## Strand Ranch Integrated Banking Project FEIR

The Rosedale-Rio Bravo Water Storage District (RRBWSD or Rosedale) as the Lead Agency, in consultation with Irvine Ranch Water District (IRWD) as a Responsible Agency, has prepared this Final Environmental Impact Report (Final EIR) to provide information about the potential effects on the local and regional environment associated with the Strand Ranch Integrated Banking Project (proposed project). The purpose of the proposed project is twofold: to augment the recharge and extraction capacity of Rosedale's Groundwater Storage, Banking, Exchange, Extraction & Conjunctive Use Program (Conjunctive Use Program); and to provide water supply reliability and redundancy to IRWD and its customers.

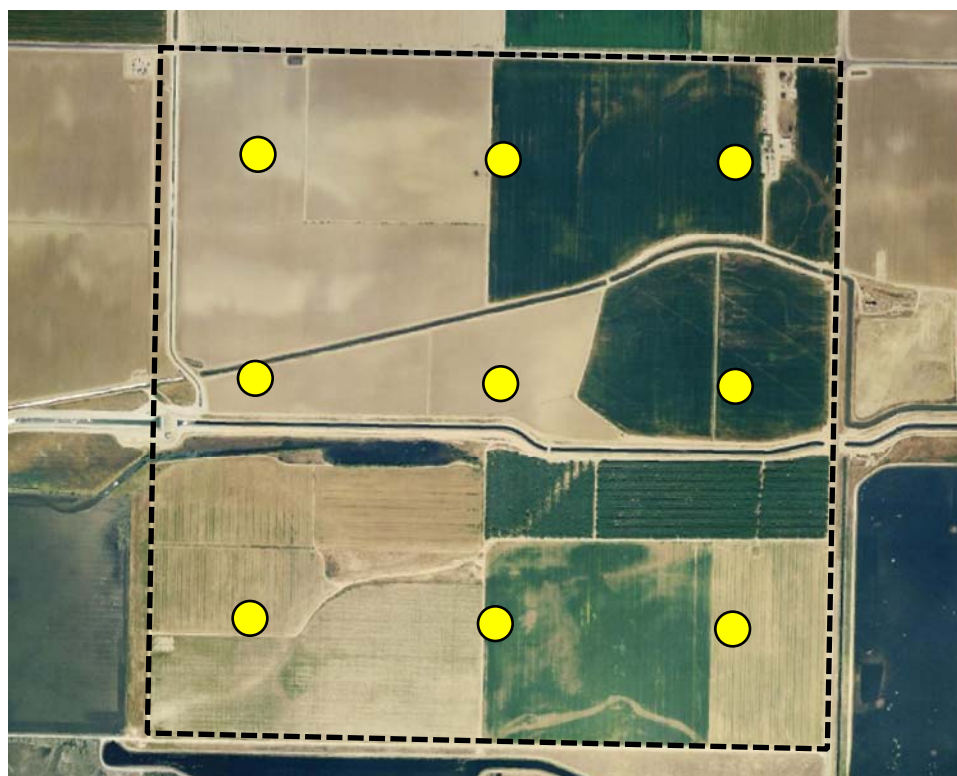
Figure 2-3 shows wells on the Strand Ranch at 1/3-mile spacing. This spacing places the southwestern well less than 1/4 mile away from an existing KWB well (30S/25E-3R). This proposed location will minimize impacts between Strand Ranch wells at the expense of creating significant impacts to this offsite well on the Kern Water Bank. The southwestern well location should be at least 1/3-mile from well 30S/25E-3R, as mitigation.<sup>11</sup>

Potential ~~Proposed~~ Well Location with 1/4 mile spacing

Figure 2-3 has been modified to say “Potential Proposed Well Locations”
